DEPARTMENT OF THE NAVY
NAVAL FACILITIES ENGINEERING SYSTEMS COMMAND PACIFIC
258 MAKALAPA DR STE 100
PEARL HARBOR HI 96860-3134

Notice No. 8
22 May 2026

PRE-PROPOSAL QUESTIONS & ANSWERS

RFP N62742-26-R-1300
WON 1665555, FY24 AJJY183012 (P-012), PDI: NORTH AIRCRAFT PARKING RAMP, ANDERSEN AIR FORCE BASE, GUAM

165. Section 33 82 00, Telecommunications Outside Plant (OSP)

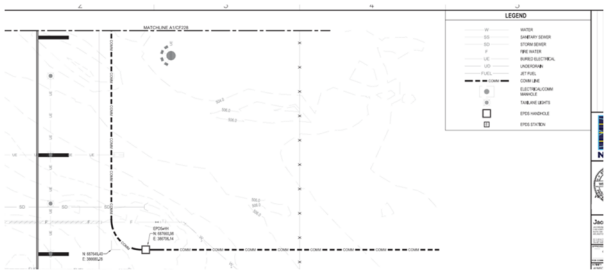
In Comm Plan, CF221-CF234, Provide Trench Drawing Details, Cross Section for bidding purposes.

ANSWER: Bid per RFP.
